Marulan South Limestone Mine

## SSD 7009 | WATER MANAGEMENT PLAN

Prepared for Boral Cement Limited  
15 August 2022

Figure 3.1 Water quality monitoring sites

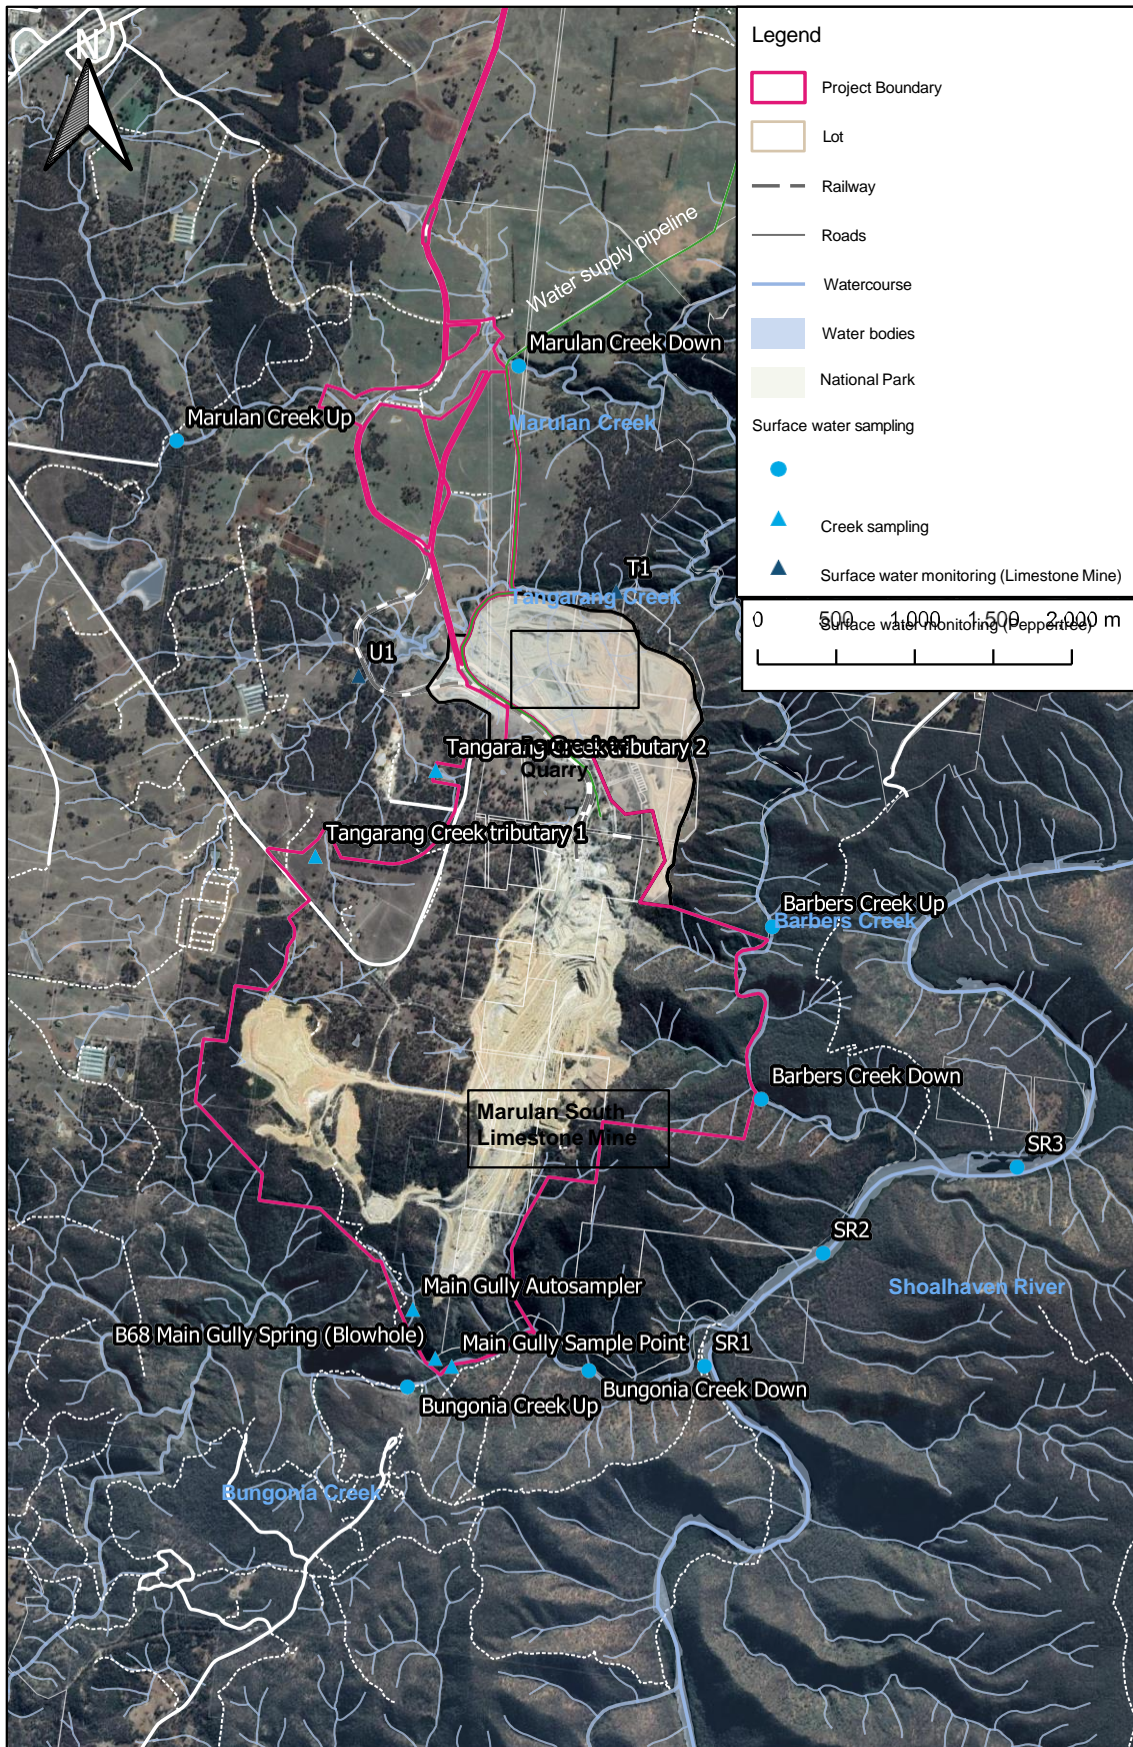
6.2.1	Section states that monitoring may cease in Barbers Creek and Shoalhaven River once NOE and WOE rehabilitation has been established. Monitoring should cease when the monitoring shows that those areas have stabilised	Adjusted sentence to include additional requirement.
	Table 6.2, 6.5 and 6.6	a reference to a map showing these locations should be included	Monitoring sites (Table 6.2) is shown in Figure 3.1. Dam and pipeline locations are shown in MSLM-WMP-ESCP-0005

Figure 5.2 Water treatment facilities

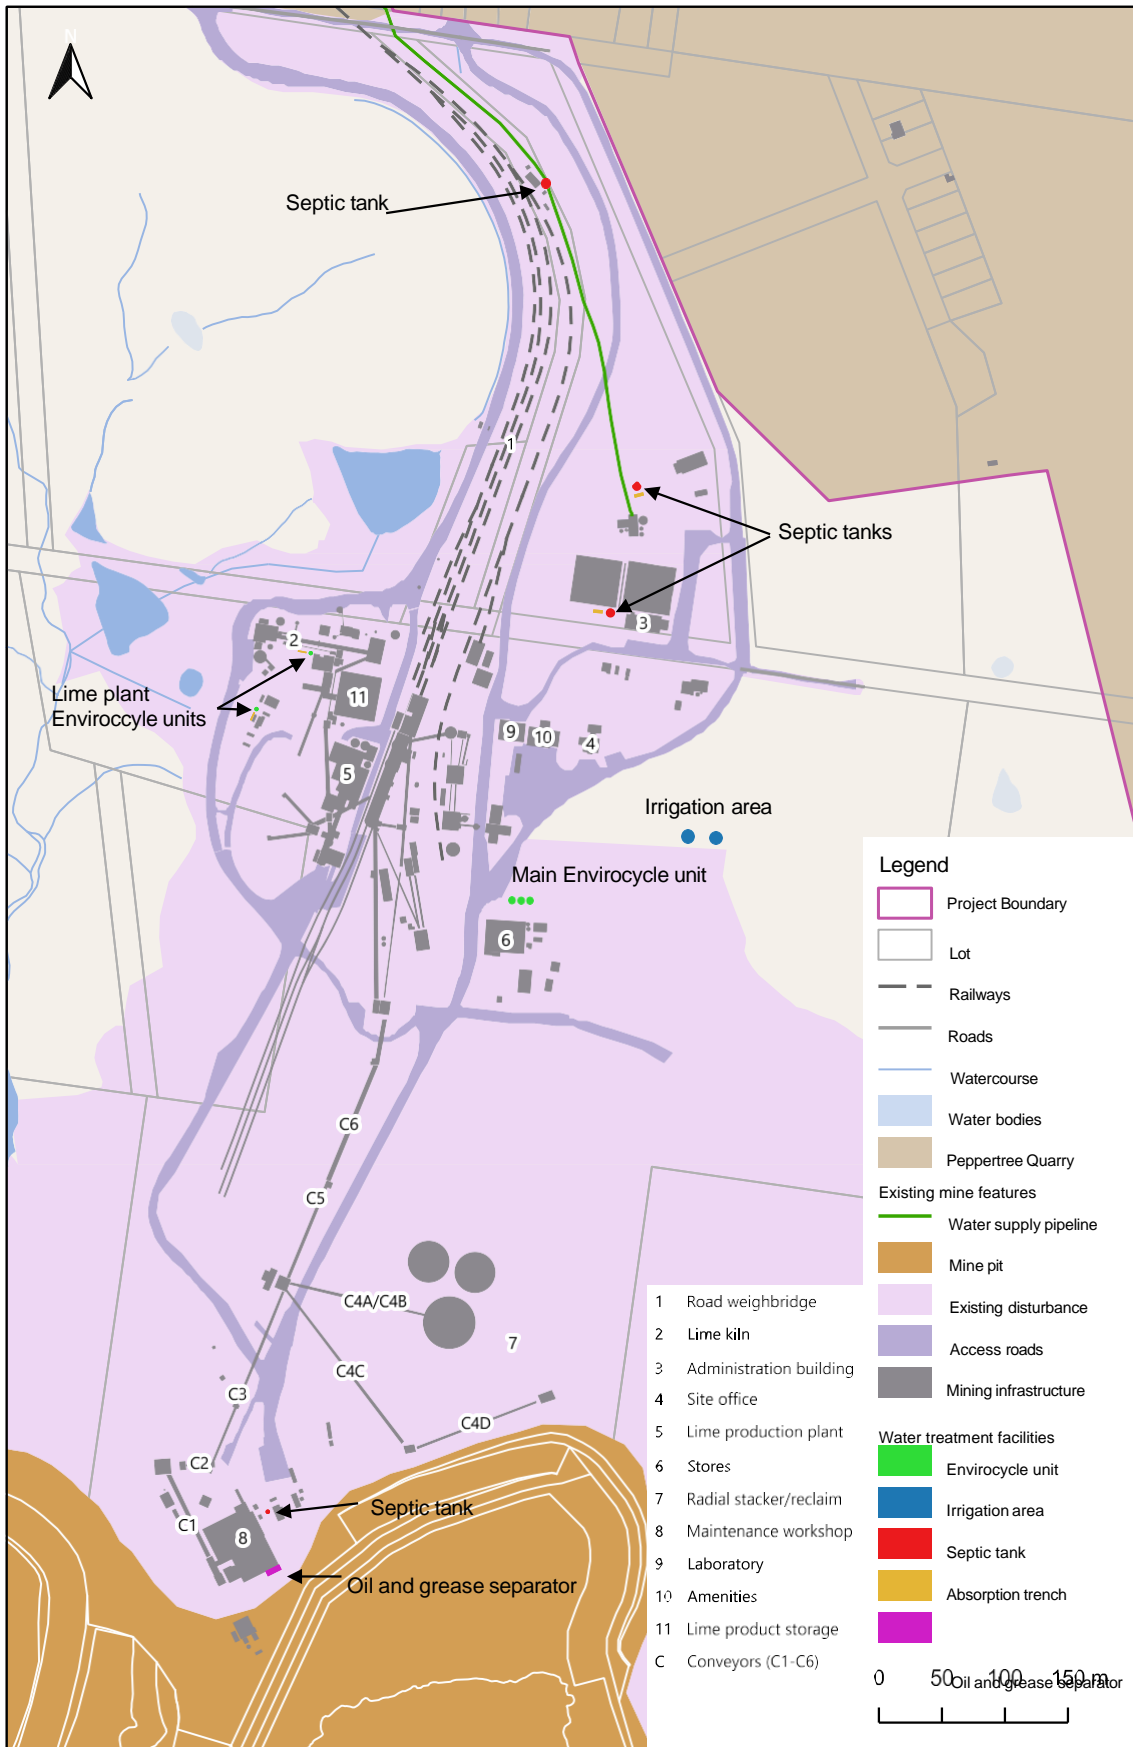
5.1.3	The location of all on-site wastewater systems, including the effluent management areas, should be shown on a plan of the site.	Additional figure (Figure 5.2) included
